# Access Compliance Report

## Public Rights-of-Way

### (Curb Ramps)

Intersection ID: 3920	Main Street: OVERLOOK_MOUNTAIN_DR	Cross Street: OVERLOOK_COVE_RD	Location: SE
ADA ID: 47D00C89A3E0	Ramp Type: PerpDiag	Initial Pass/Fail: Fail	Overall Compliance: No
Severity Score: 25			
Codes/Mitigation Info/Possible Solution		Field Measurements/Component Compliance

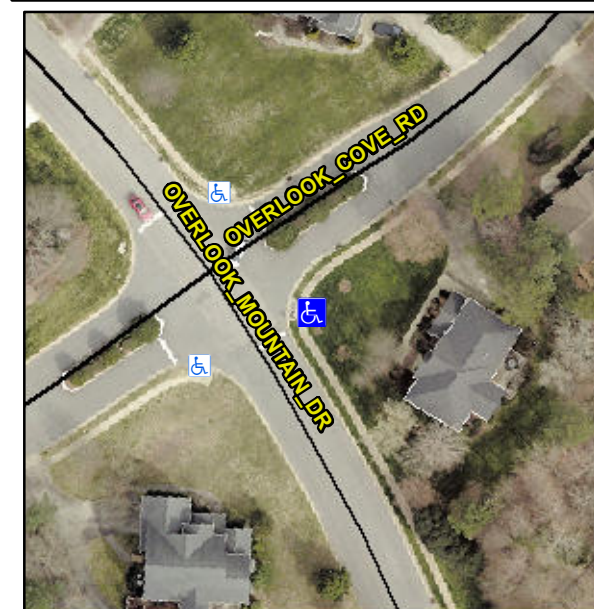
**Not Found, R304.5.3**

Compliance	Description	Data	Compliance	Description	Data
N/A	Ramp Length (in)	47.0	Yes	Ramp Slope (%)	5.9
Yes	Ramp Width (in)	127.0	No	Ramp XSlope (%)	13.0
N/A	Flare Type LT	N/A	N/A	Flare Type RT	N/A
N/A	Flare Slope LT (%)	N/A	N/A	Flare Slope RT (%)	N/A
N/A	Flare Traversable LT?	N/A	N/A	Flare Traversable RT?	N/A
N/A	Landing Length (in)	N/A	N/A	DWS Provided?	N/A
N/A	Landing Width (in)	N/A	N/A	DWS Contrast?	N/A
N/A	Landing Slope (%)	N/A	N/A	DWS Length (in)	N/A
N/A	Landing X Slope (%)	N/A	N/A	DWS Full Width?	N/A
N/A	Landing Curb? (Y/N)	N/A	N/A	DWS Offset (in)	N/A
N/A	Shared Landing?	N/A			
N/A	Gutter Ponding?	N/A	N/A	Gutter Slope (%)	N/A
N/A	Gutter Lip Ht (in)	N/A	N/A	Gutter X Slope (%)	N/A
N/A	Painted X Walk1?	No	N/A	Painted X Walk2?	No
	X Walk 1 Direction	To NW		X Walk 2 Direction	To SW
N/A	X Walk 1 Width (in)	N/A	N/A	X Walk 2 Width (in)	N/A
	X Walk 1 Slope (%)	6.3		X Walk 2 Slope (%)	1.4
	X Walk 1 X Slope (%)	4.9		X Walk 2 X Slope (%)	7.3

**Remove & Replace Curb Ramp With Two New Directional Ramps or Equivalent.**
